Three Mile Island Nuclear Station, Unit 2 (TMI-2)  
Operating License No. DPR-73  
Docket No. 50-320  
Sediment Transfer and Processing Operations  
Safety Evaluation Report

SA # 4340-3233-85-088

Rev. # 1  
Page 1  
of 41

**SAFETY EVALUATION REPORT**  
for  
**SEOIMENT TRANSFER AND PROCESSING**  
**OPERATIONS**

SIMPLIFIED P&ID FOR  
SLUDGE PROCESSING SYSTEM

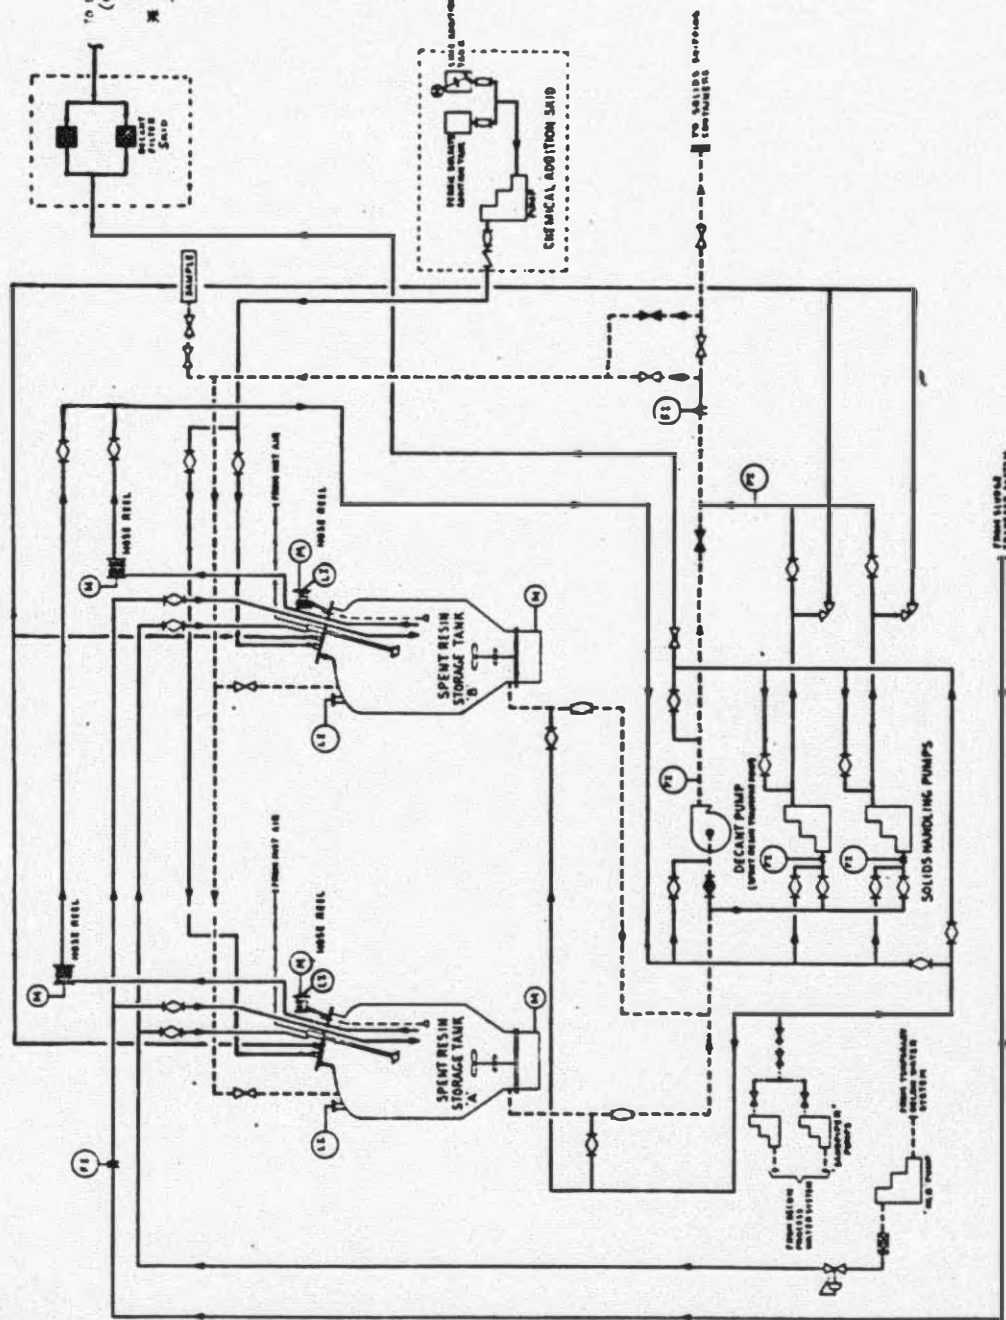
Rev.	SUMMARY OF CHANGE	Approval	Date
1	<p>p. 11, 12, 20, 22; Added, "As an option, supernate from reactor building processed sludge can be transferred directly back to the reactor building basement without being held up in the neutralizer tanks".</p> <p>p. 20; Deleted, "As an option, this water will be available for flushing the tank(s) and process lines".</p> <p>p. 26; Added, "Whereas, during transfer directly back to the reactor building basement, the effluent from decant does not pass through the WDL system".</p>	CJD	6-2-86

AS AN OPTION, EFFLUENT CAN BE  
TRANSFERRED DIRECTLY FROM THE  
REACTOR BUILDING BASEMENT.

The supernate is drawn into the 1" diameter flexible decant hose using the existing Spent Resin Transfer Pump (WDS-P-1) as the decant pump. The supernate is pumped at a rate of approximately 15 gpm through the decant filter skid which includes two backflushable filters in parallel, that are designed to remove all particles larger than approximately 20 microns. After filtration, the liquid is transferred to the Neutralizer Tanks and processed through the SDS. As an option, supernate from reactor building processed sludge can be transferred directly back to the reactor building basement without being held up in the neutralizer tanks.
